CALL NO. 108  
CONTRACT ID NO. 131221  
ADDENDUM # 1

Subject: Perry County, STP BRZ 1003 (229)  
Letting November 22, 2013

- (1) Revised - Plan Sheets
- (2) Revised - Bid Items - Pages 188-189(c) of 189 (This is to replace the incorrect bid items that were included in the original proposal)

# GENERAL NOTES, LEGEND, & GENERAL SUMMARY, GLOMAWR BRIDGE REPLACEMENT GAS UTILITY RELOCATION

U5

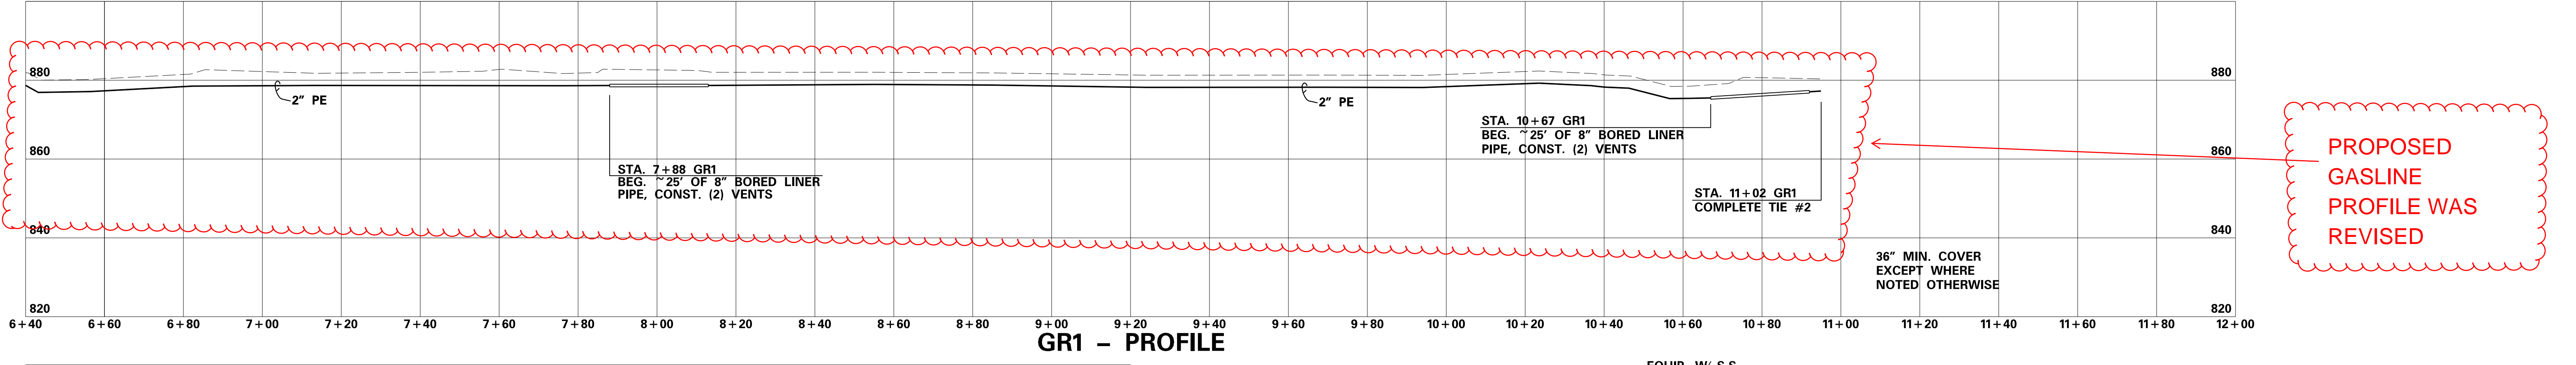
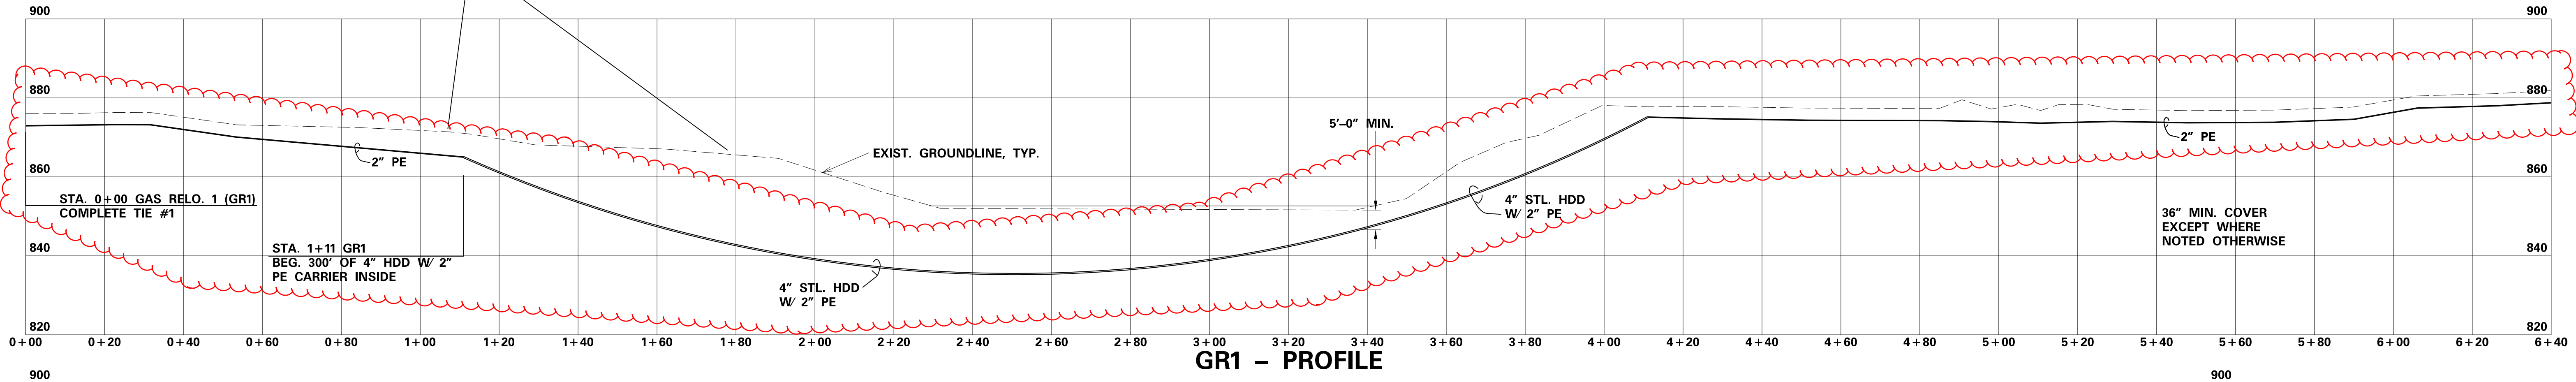
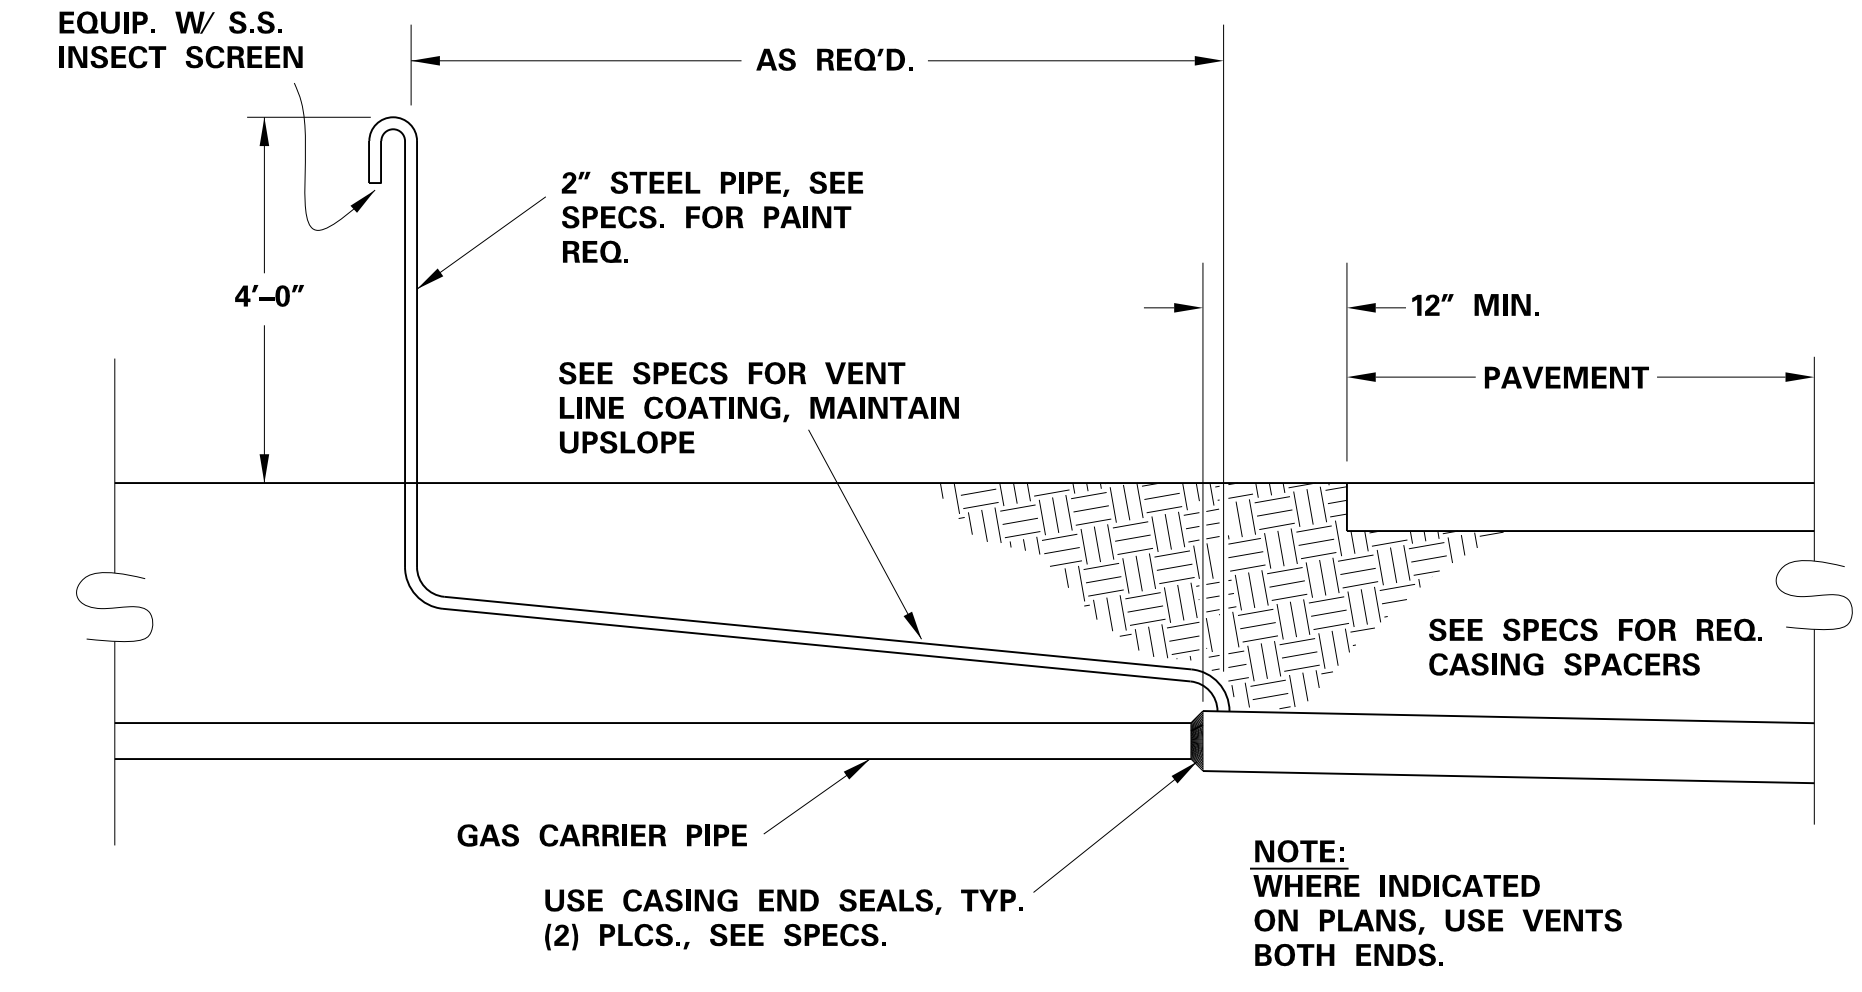
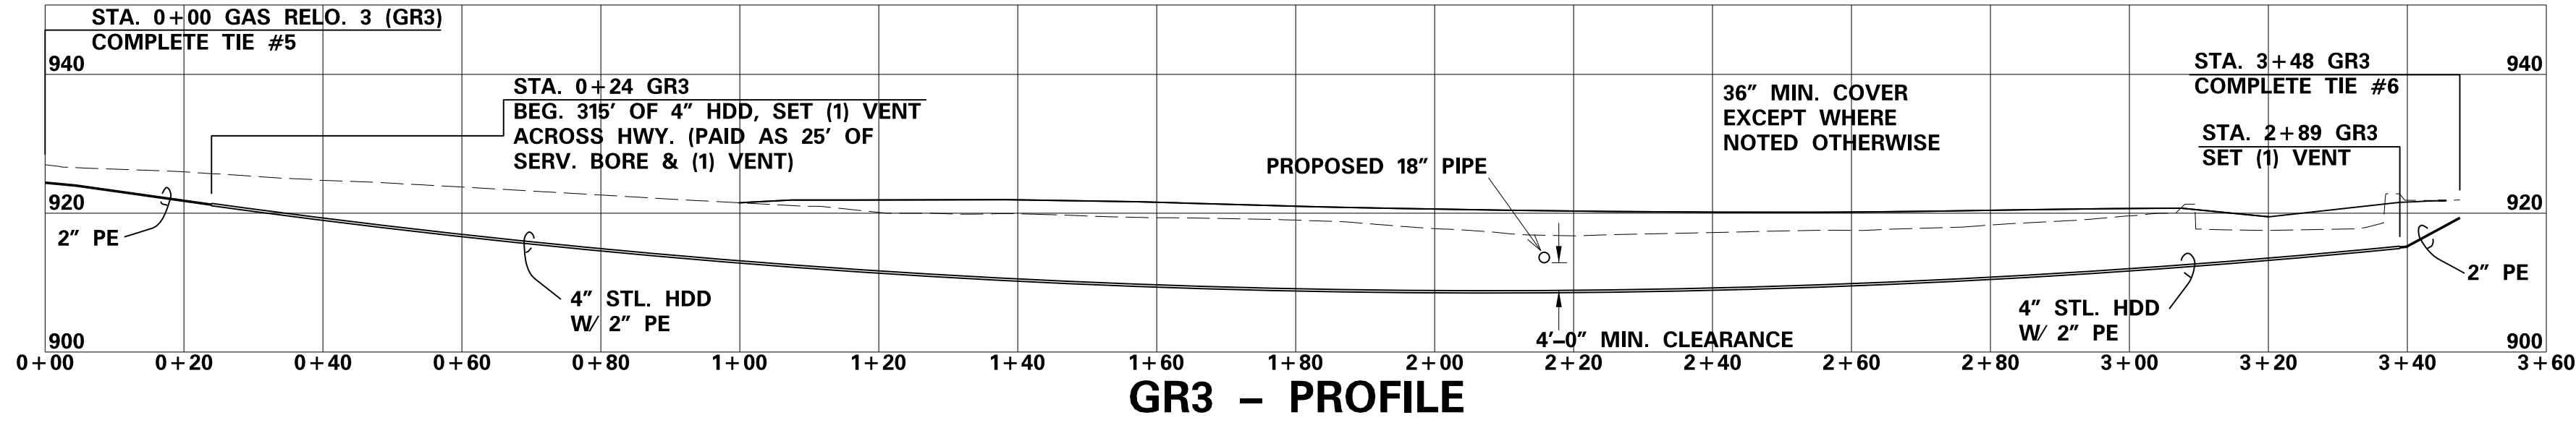
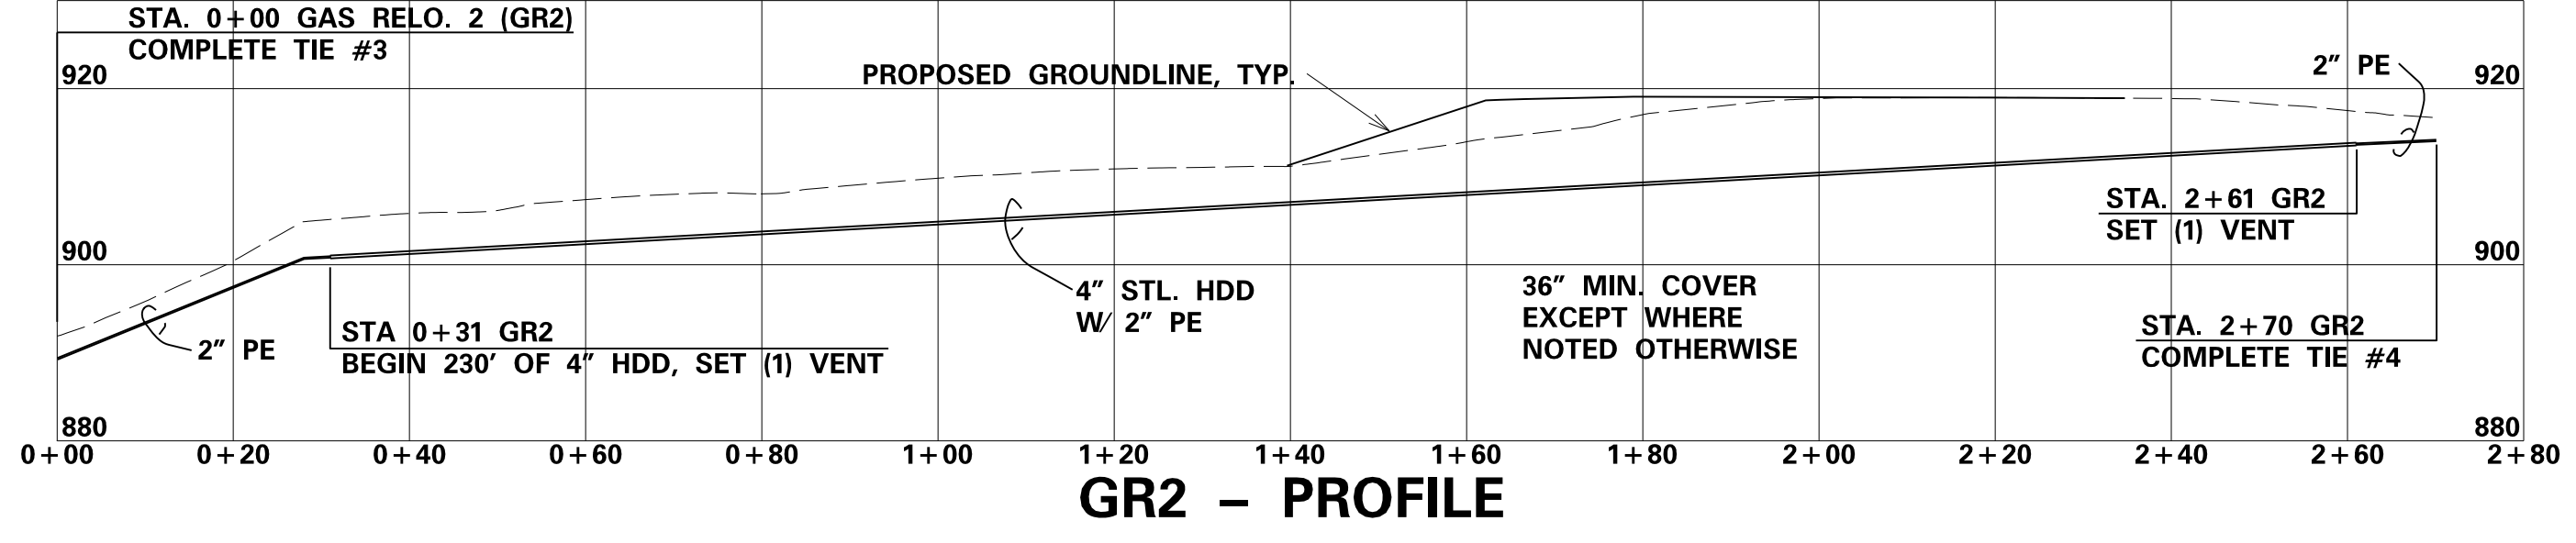
PROPOSED  
GASLINE  
PROFILE WAS  
REVISED
